TO: Winnebago Industries, Inc. Dealers

SUBJECT: Campaign #122 – LP Line Interference

INSTRUCTIONS TO PERFORM CAMPAIGN 122

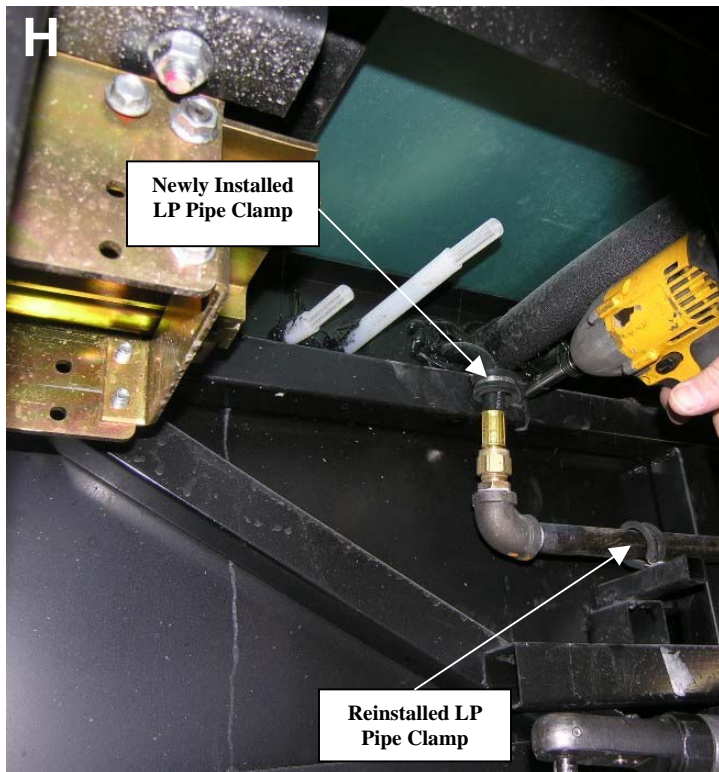
9. Ensure LP pipe is snug to vertical support tube. If not, remove LP pipe clamp and reinstall clamp (as shown), ensuring that LP pipe is snug to the vertical support tube. See Photo G.

10. Take additional LP pipe clamp and install to upper horizontal support tube. See Photo H.
